Reply to Referee #2: Kenneth Davis

We would like to thank Kenneth Davis for his detailed and constructive feedback on this manuscript. We restructured the paragraphs and sections as best as possible and hope this has increased the readability and the impact of the work. Our responses to each comment are provided below in black font, and the Referee's comments are indicated in blue. Unless stated otherwise, all page and line numbers refer to the originally submitted manuscript.

Figure R1. Mean vertical wind velocity in dependence on the horizontal wind direction, based on all measurements where wind speed was $> 1 \text{ m s}^{-1}$.

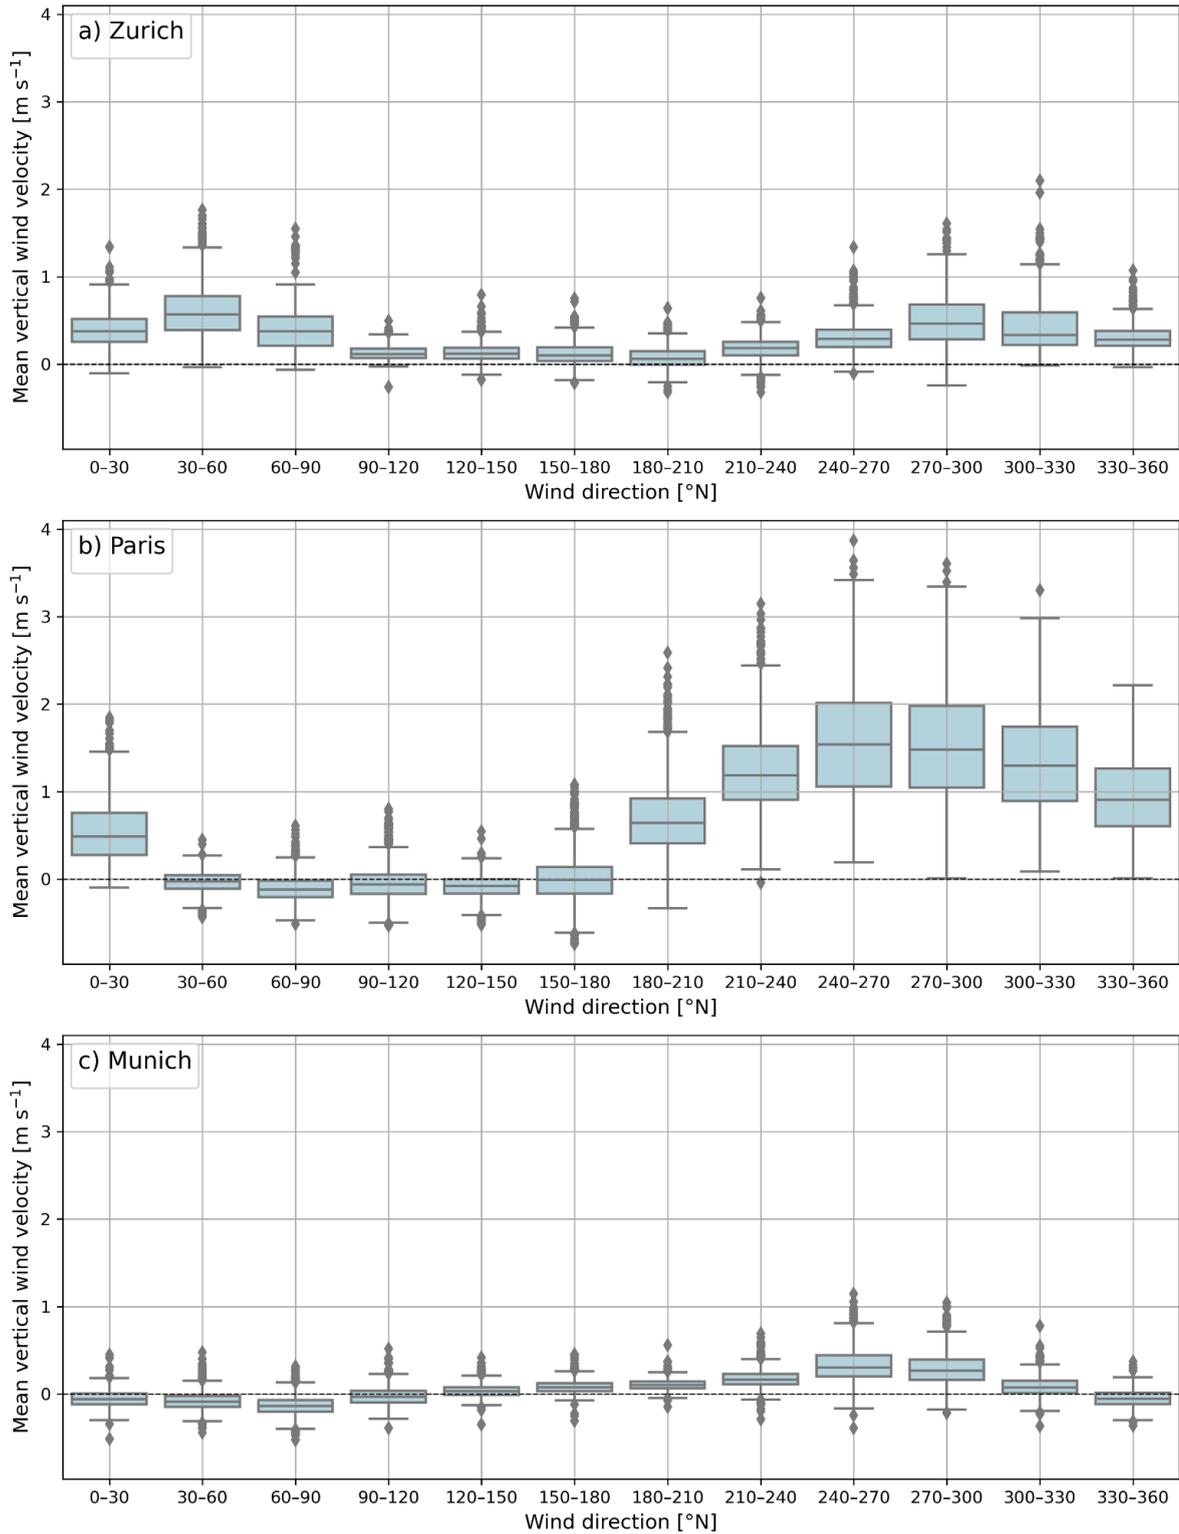
9. Line 106-110. Is there any directional dependence of the mean vertical velocities? How sensitive are the results to the methods used to compute the deadband?

Yes, the mean vertical wind velocities show a directional dependence (Fig. R1), which can be attributed to instrument tilt and flow distortion caused by the tower structure. However, deviations from horizontal wind are considered small, especially in Zurich and Munich (see also Hilland et al. (2025), Lan et al. (2024), and our response to Referee #1 Comment 11). Above all, these deviations are taken into account in the EC measurements through coordinate rotation during data processing, and in the REA measurements through adjustment of the deadband. While the method used to compute the deadband affects the magnitude of the concentration differences between the updraft and downdraft reservoirs, the beta coefficient calculated from CO₂ for each measurement period individually accounts for the deadband used when calculating fluxes (Pattey et al., 1993). Therefore, the results are independent of the method used to compute the deadband.

We added a note regarding the independence of the results on the method used to compute the deadband to Line 110 (Line 122 in the resubmitted manuscript).

Figure R2. Number and percentage of retained measurements after quality control and filtering of the continuous CO₂ flux measurements from the IRGASON.

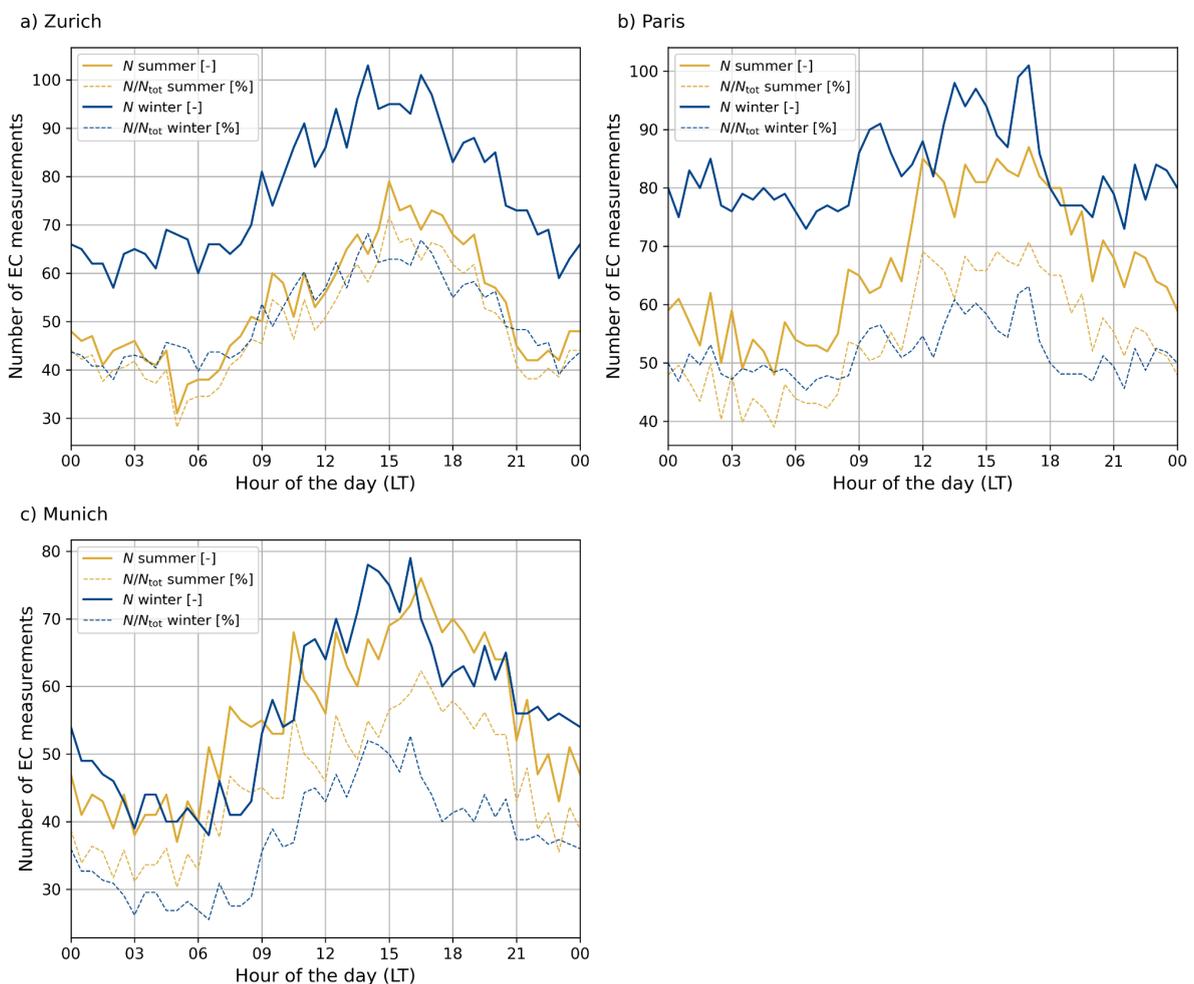
37. Figure 3, caption. What are the time periods covered by the continuous EC fluxes? Is there any place where the number of EC data points per averaging interval is reported? I don't think this is essential to your story but it would be good to document.

The IRGASON fluxes shown in Fig. 3 of the manuscript cover the entire time periods of the measurement campaigns (Table 2 in the manuscript). After quality control, between 40 and 100 measurements, or 40 to 70 % of the total number of time periods, were available for each 30 min period (Fig. R2). It is important to note that the continuous IRGASON flux measurements were only shown as reference. For quantitative analysis of the REA measurements, the fluxes measured during the individual REA measurement periods by the MGA⁷ or, if not available, by the IRGASON, were used.

Nevertheless, we added the information in Appendix D of the resubmitted manuscript with a reference in the caption of Fig. 3.
